**Proposal for a Supplement
to UN/ECE Regulation 67- 01 (Equipment for LPG)
with a view to introduce specific requirements for the type-approval of
all-composite LPG containers.**

Transmitted by the Expert from the Netherlands

Figure 1 : description of the impact test procedure :

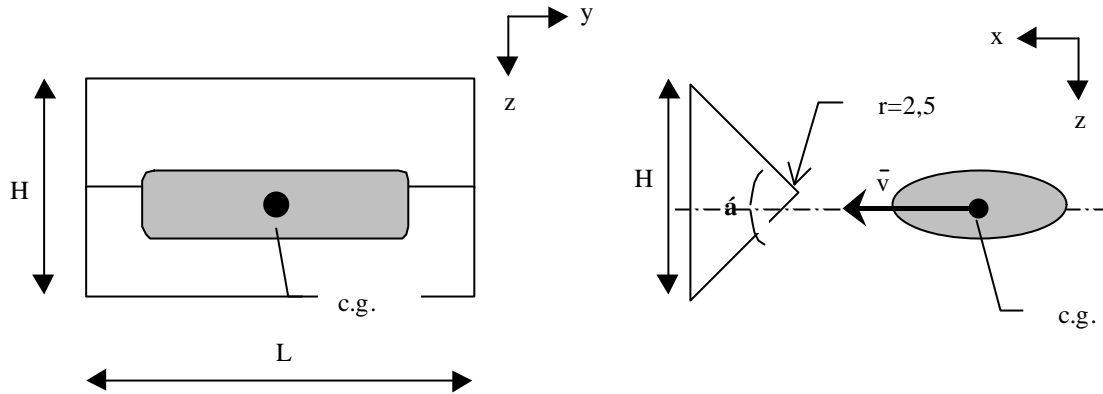
New paragraphs are added to introduce specific tests requirements to safeguard the good construction and design of all-composite containers :

New paragraph 2.7. and 2.8 , to read:

A container filled with the fluid medium to the weight that equals the filling with 80% of LPG with a reference mass of 0.568kg/l, is projected, parallel to the length axle (x-axes in Figure 1) of the vehicle in which it is intended to be fitted at a velocity, V of 50km/h, against a solid wedge, fixed horizontally, perpendicular to the movement of the container.

The wedge shall be installed so that the centre of gravity (c.g.) of the container hits the centre of the wedge.

The wedge shall have an angle \hat{a} of 90 degrees and the point of impact shall be rounded with a maximum radius of 3 mm.

The length of the wedge L, shall be at least equal to the width of the container in respect to its movement during the test. The height H, of the container shall be at least 600 millimetres
